Z17-0001/PD17-0001/TM17-1531 Cameron Ranch Subdivision

MEETING DATE: July 24, 2017
FILE NO.: Z17-0001,PD17-0001,TM17-1531
PROJECT: CAMERON RANCH
APPLICANT: Starbuck Road 56 CA LLC/R.E.Y. Engineers, Inc.

DESIGN REVIEW COMMITTEE COMMENTS

TYPICAL ROAD SECTION 39.0' RIGHT OF WAY
 D DRIVE - PARKING ON BARRIER CURB SIDE ONLY N.T.S.

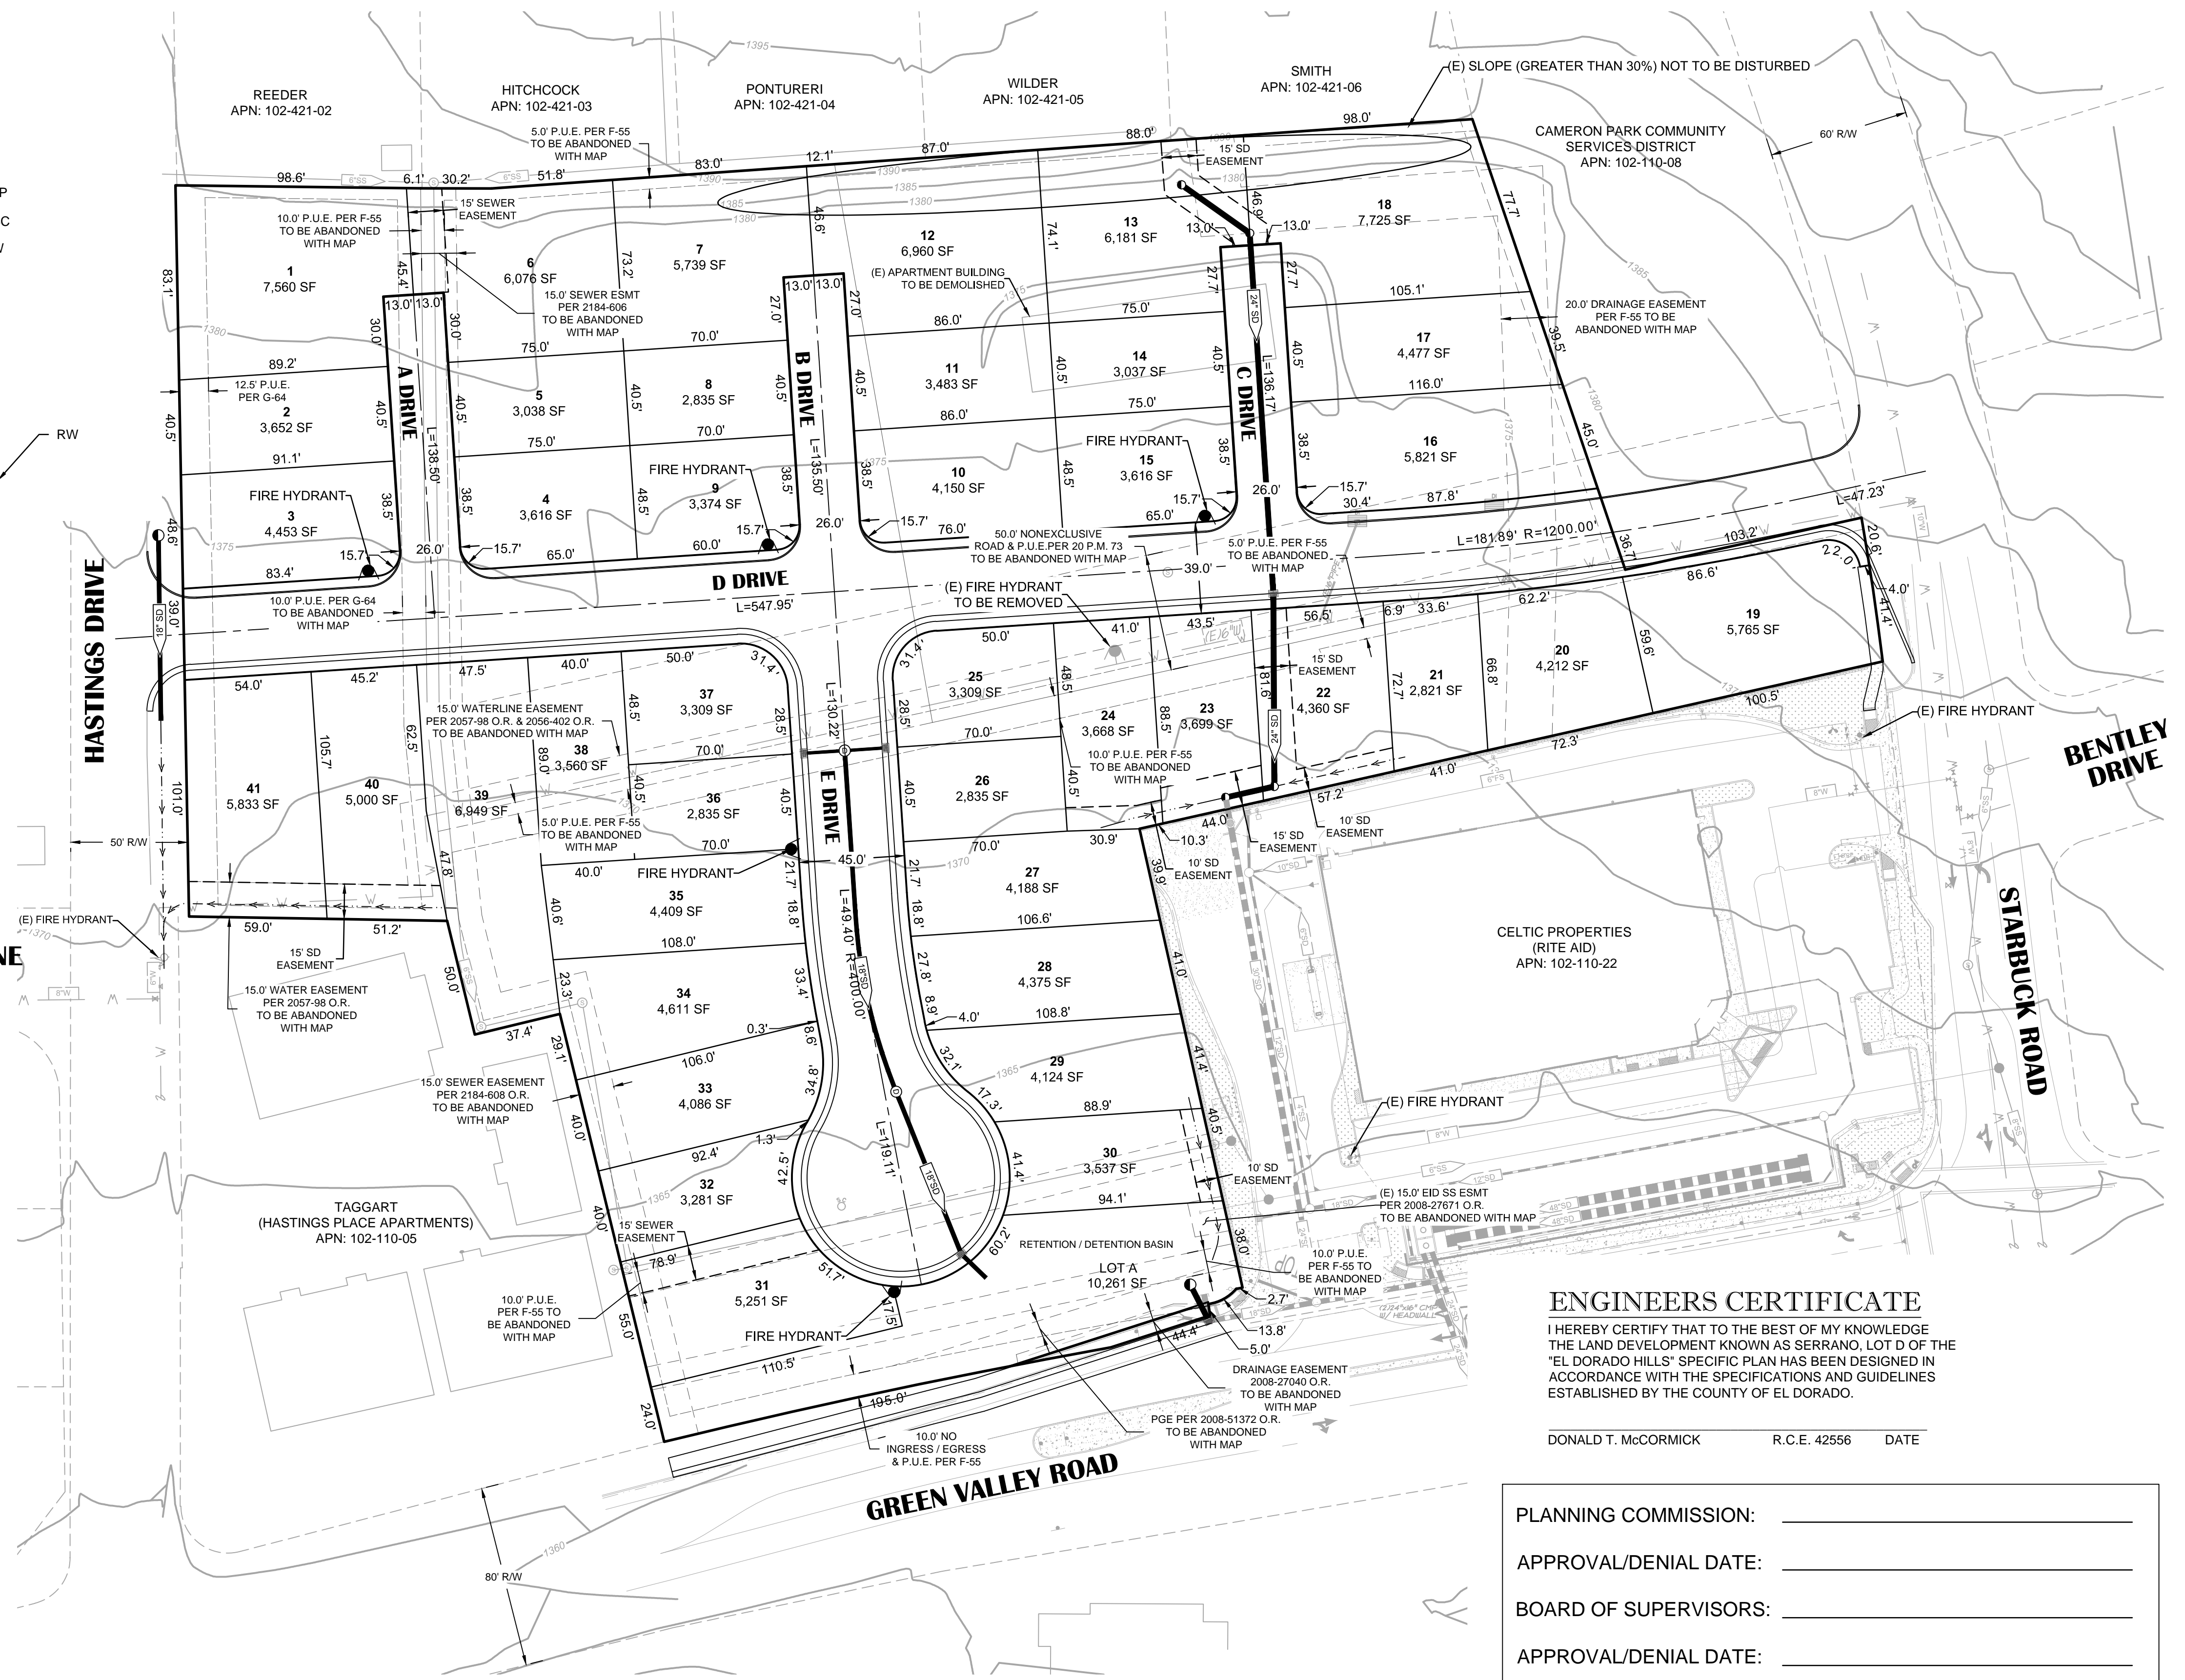
Parking is not well addressed in this project; visitor parking is non-existent. Project should show adequate on-street parking and room for guest parking. Developer stated an HOA would take care of streets and front yards.

Streets should be wide enough to accommodate parking, sidewalks and emergency vehicle access requirements.

Parking is an issue. More should be provided
